**GARD proposal for matters to be addressed by
Ofwat/RAPID in its final decision
on the SESRO Gate 3 report**

28th January 2026

**GARD
Rivendell
142 The Causeway
Steventon
Oxfordshire OX13 6SJ
groupagainstreservoirdevelopment.org
gard.chair@gmail.com**

Figure 4.2 - Evolution of 'Baseline' habitat scores for 'core' SESRO area

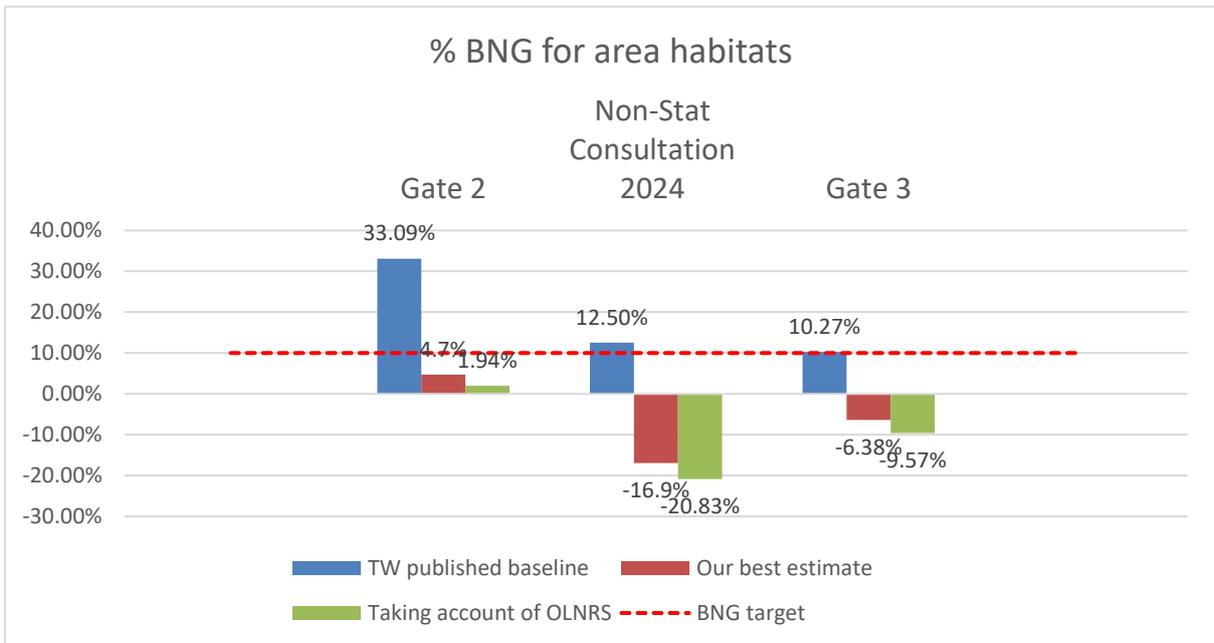
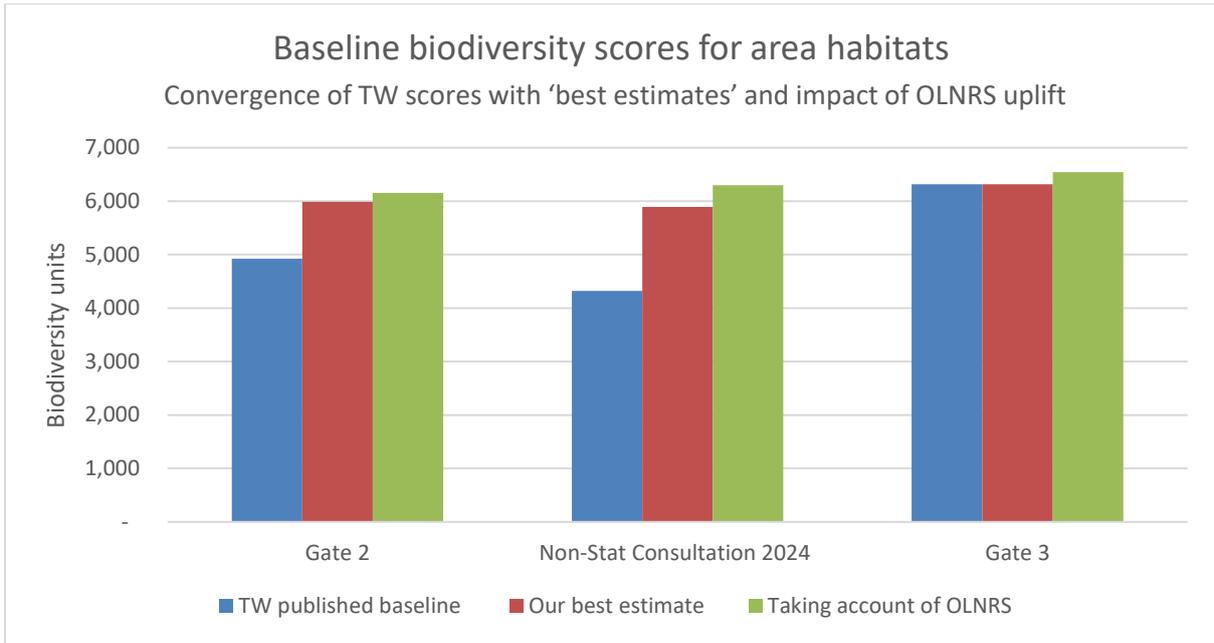
The evolution of reported BNG scores are compared with our expert evaluation below in Figure 4.2 and detailed in Appendix F. This shows scores for the SESRO land-take prior to the latest expansion for the pre-DCO consultation.

'Our best estimate' indicates the result of the evaluations in GARD's 2024-JPP Report. The picture is very inconsistent across the different habitat maps and BNG calculations. Overall, at each stage, different assumptions have been made, with poor levels of justification. Our main concerns with SESRO's approach to BNG at each stage of the SESRO process to date are summarised below.²²⁵

Figure 4.3 - Increase of Reservoir embankment covered by woody habitats, 2022–25

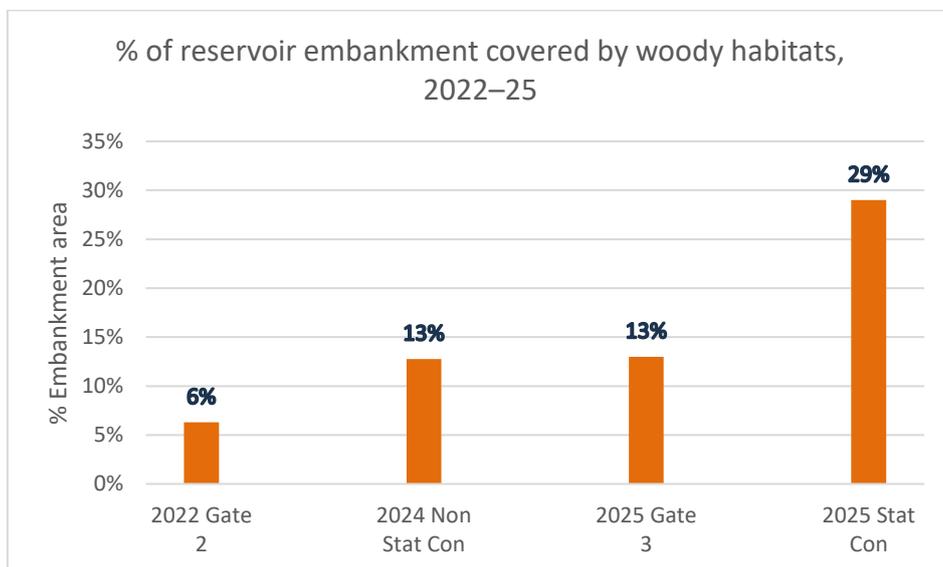
- In the Gate 3 Reports and in the DCO consultation, the impacts of the draft OLNRS on BNG calculations were not considered.
- From the non-Statutory Consultation onwards, the BNG has been maintained above 10% by extensive tree planting on the Reservoir embankment, which is likely to jeopardise Reservoir safety. The use of Reservoir embankments to maximise BNG opportunities on site is a cause for concern in terms of the integrity of the embankment, particularly from root growth and from burrowing animals, such as badgers. Figure 4.3 below shows that the proportion of embankment with woody habitats has risen from 6% at Gate 2 to 29% at the Statutory Consultation stage. These habitats are vaguely defined as “*intermittent trees and shrubs*”, “*woodland and copse*”, “*scrub*” (2024) and “*woodland and copse*” and “*scrub*” in the Statutory Consultation (2025). It has been suggested in informal discussions²²⁷ that this planting would be hawthorn and other low-growing species; however, the consultation brochures and artists’ impressions show lush woodland, rather than low scrub.

Figure C.2 - Gate 3 submission for SESRO, August 2025

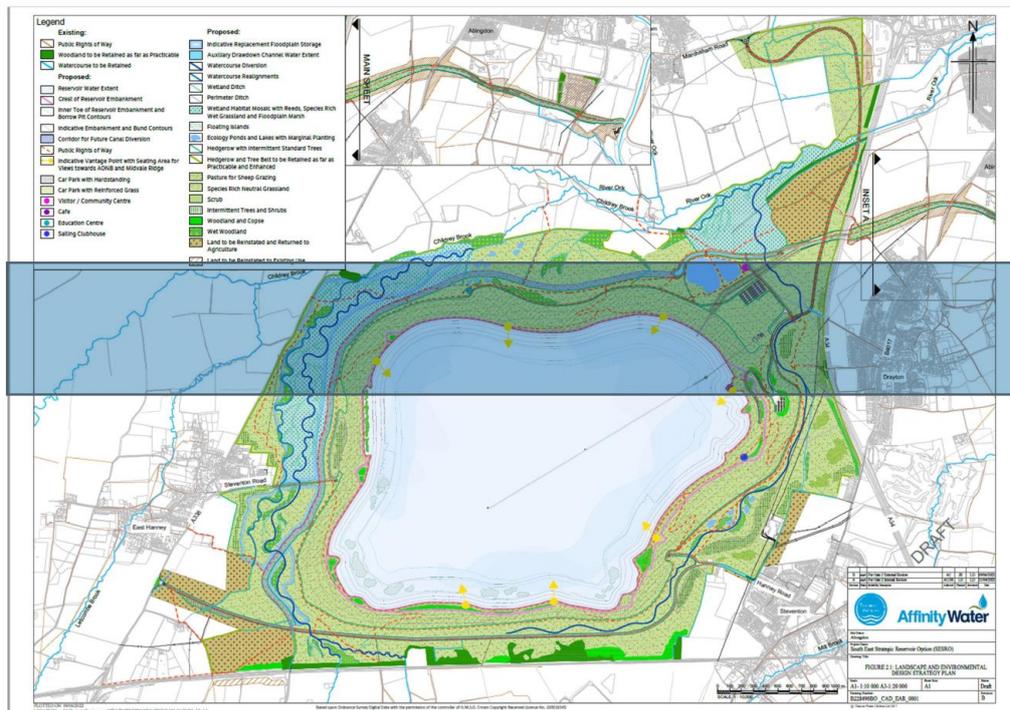
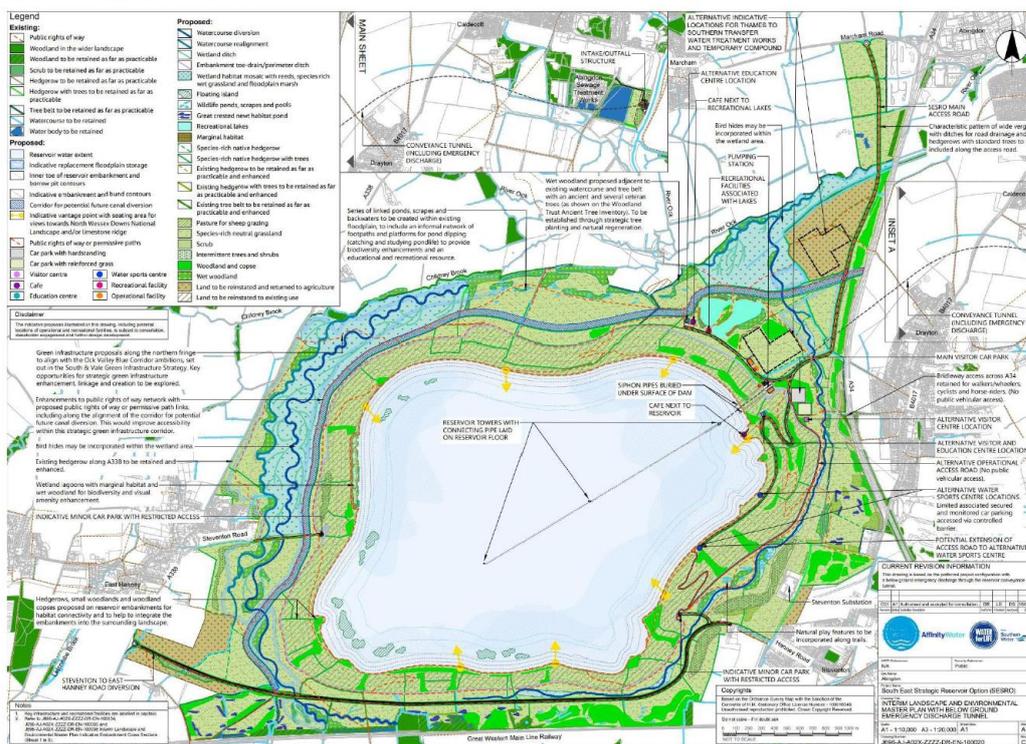
This appendix identifies any major changes between the SESRO Gate 2 and 3 high-level design proposals that could explain the significant tripling of the Capex estimate, from £2,745M to £6,604M (2022/23 price base). In undertaking this comparison, the expectation is that the cost estimate for each Gate aligns with the design description, as shown in the drawings for the proposed works (see Figure C1 and Figure C.2 below).
